RE: Site Plan and Traffic Review for "Edgewater," City of Beacon, NY;
CM Project #117-083.1

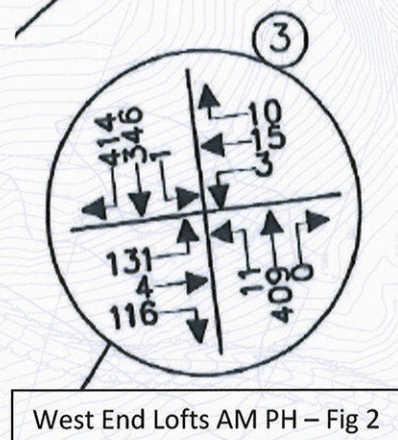
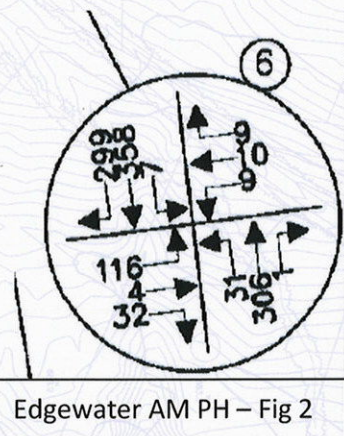
5. The traffic counts included in Appendix E are cut off; they appear scanned as portrait rather than landscape leaving about 25% cut off. Turning movement counts for Route 9D at Verplanck Avenue, Beekman/West Church, and Main St/Municipal Place are missing from Appendix E.
6. We note some differences in the existing traffic volumes between the Edgewater study and the West End Loft study. For example, the Beekman Avenue/West Church Street/Route 9D intersection has a few movements that are 80 to 115 vehicles different (below). Were different volumes used at the common intersections between the two studies?
